SEWAGE DISPOSAL SYSTEM

DEPARTMENT OF HEALTH AND MENTAL HYGIENE

HOWARD COUNTY HEALTH DEPARTMENT

SUBDIVISION LOT ROAD 13883 Triadelphia Road

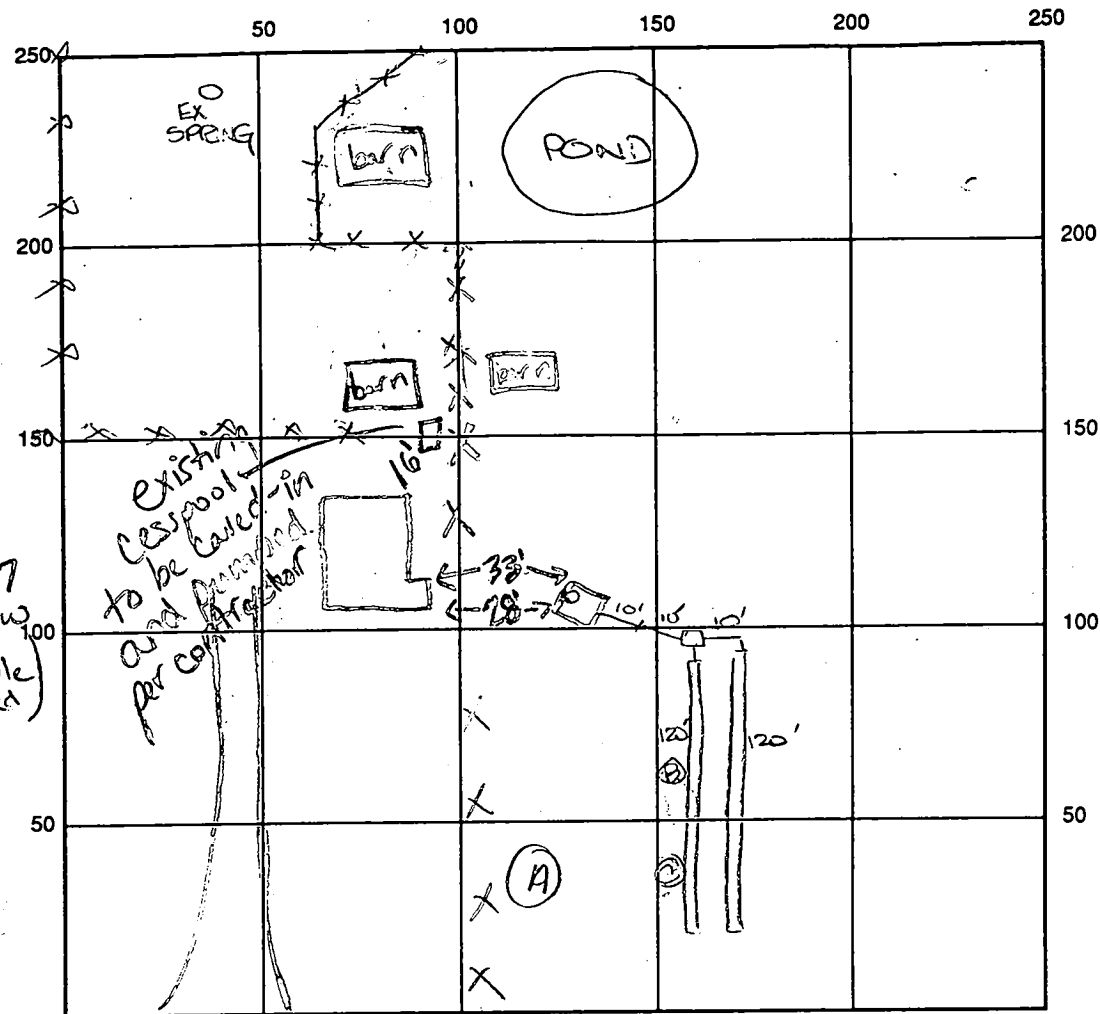
REMARKS: 6.8.98 ok to continue with trenches, will call for inspection tomorrow am. (km)

6/9/98 ok to cover all septic work. Needs house connection. Failing system to be abandoned when new system is put into service. DKS

6/10/98 house connection ok w/o insp - No final until abandonment

7/7/98 received certification of abandonment of failing system. DKS
